Access Compliance Report

Public Rights-of-Way

Intersection ID: 30083	Main Street: J_W_CLAY_BV	Cross Street: VILLAGE_SHOPPING_CENTER_DR	Location: SE
ADA ID: 180A27F19AD5	Ramp Type: PerpDiag	Initial Pass/Fail: Fail	Overall Compliance: No
Severity Score: 30			
Codes/Mitigation Info/Possible Solution		Field Measurements/Component Compliance

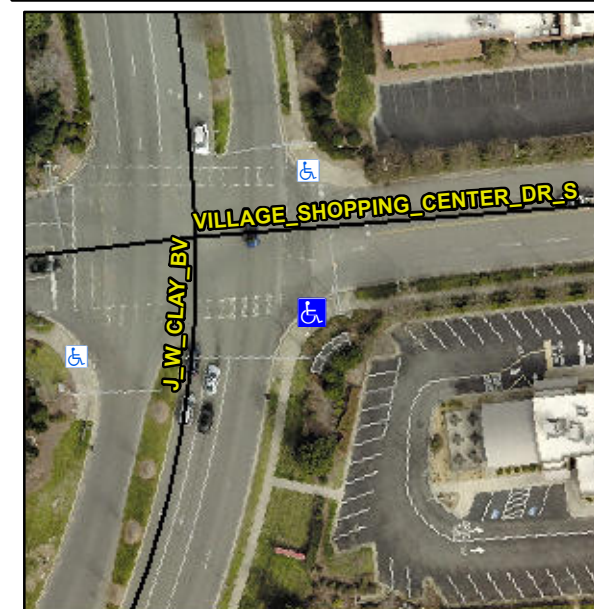
Not Found, R304.5.1, R304.2.2

Compliance	Description	Data	Compliance	Description	Data
N/A	Ramp Length (in)	112.0	No	Ramp Slope (%)	8.9
No	Ramp Width (in)	35.5	Yes	Ramp XSlope (%)	0.1
N/A	Flare Type LT	N/A	N/A	Flare Type RT	N/A
N/A	Flare Slope LT (%)	N/A	N/A	Flare Slope RT (%)	N/A
N/A	Flare Traversable LT?	N/A	N/A	Flare Traversable RT?	N/A
N/A	Landing Length (in)	N/A	N/A	DWS Provided?	N/A
N/A	Landing Width (in)	N/A	N/A	DWS Contrast?	N/A
N/A	Landing Slope (%)	N/A	N/A	DWS Length (in)	N/A
N/A	Landing X Slope (%)	N/A	N/A	DWS Full Width?	N/A
N/A	Landing Curb? (Y/N)	N/A	N/A	DWS Offset (in)	N/A
N/A	Shared Landing?	N/A			
N/A	Gutter Ponding?	N/A	N/A	Gutter Slope (%)	N/A
N/A	Gutter Lip Ht (in)	N/A	N/A	Gutter X Slope (%)	N/A
N/A	Painted X Walk1?	No	N/A	Painted X Walk2?	No
	X Walk 1 Direction	To N		X Walk 2 Direction	To W
N/A	X Walk 1 Width (in)	N/A	N/A	X Walk 2 Width (in)	N/A
	X Walk 1 Slope (%)	6.5		X Walk 2 Slope (%)	3.6
	X Walk 1 X Slope (%)	3.3		X Walk 2 X Slope (%)	2.5

Remove & Replace Curb Ramp With Two New Directional Ramps or Equivalent.
